RAI CLARIFICATION -- PROPOSED ALTERNATIVE ISI-020

The response provided below clarifies the following information from References 1 and 2.

Figure 1: Calvert Cliffs Unit 2 Beltline Flow Map

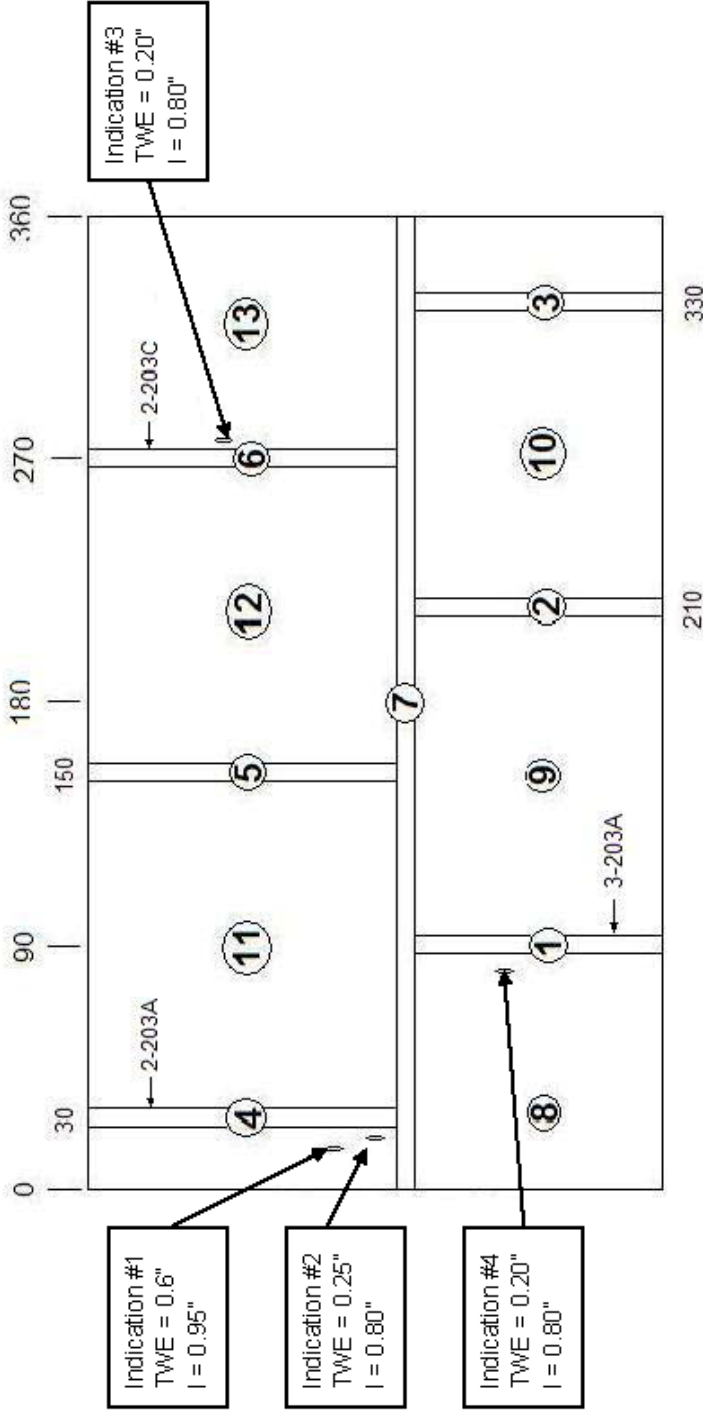
Regarding ISI-020, Table 2 in the original request [Reference 1] mentions an indication in a plate that did not meet the allowable flaw requirements for the proposed voluntary PTS rule. It says that additional information regarding the flaw is provided in Table 3. We don't see anything in Table 3 of the original request and no mention in Table A of the answer to RAI question #1 [Reference 2] of a flaw in plate material.

We believe this question emerges because the subject plate indication is listed under the scanned weld number (weld number 2-203A) in our submittals [i.e., designated as indication 1 on Figure 1 of Attachment 1 (Reference 1) and designated as indication 3 of Table A in Attachment 1 (Reference 2)]. Plotting of the indication in relationship to the weld centerline coordinates puts it in the region of plate material adjacent to the weld. Treating it as a flaw in the plate was the more conservative approach under the risk informed assessment.

⁽¹⁾ As indicated in Table 2, there are four flaws in the beltline region of the reactor vessel. Three of these flaws meet the “Allowable Number of Flaws” criteria in SECY-07-0104. However, one flaw, with a through wall extent of 0.60 inches exceeds the criteria. The location of all four flaws relative to the beltline materials is illustrated in Figure 1. The circled numbers in Figure 1 correspond to the regions in Table 3. While one flaw is outside the limits in SECY-07-0104 it is not expected that this flaw would increase the Calvert Cliffs Unit 2 TWCF value above that of the pilot plant for the following reasons:

- This plate which the flaw is located in has a maximum RT_{NDT} + ΔT₃₀ of 141.74°F and is not the limiting material in the beltline region. Furthermore, the peak fluence occurs at the 10, 80, 100, 170, 190, 260, 280, and 350 degree positions and was used to calculate the ΔT₃₀ shift for this plate. The fluence at the 30 degree position where longitudinal weld 2-203A is located in less than 60% of that of the peak fluence. Therefore, the actual RT_{NDT} + ΔT₃₀ at the specific location of this flaw is less than 141.74°F ([projected to be below 130°F](#)).

Note that Indication #1 is the indication that exceeds the limits in SECY-07-0104. The indication has a through-wall extent of 0.6", a length of 0.95" and is 0.4" beneath the cladding-to-base-metal interface.
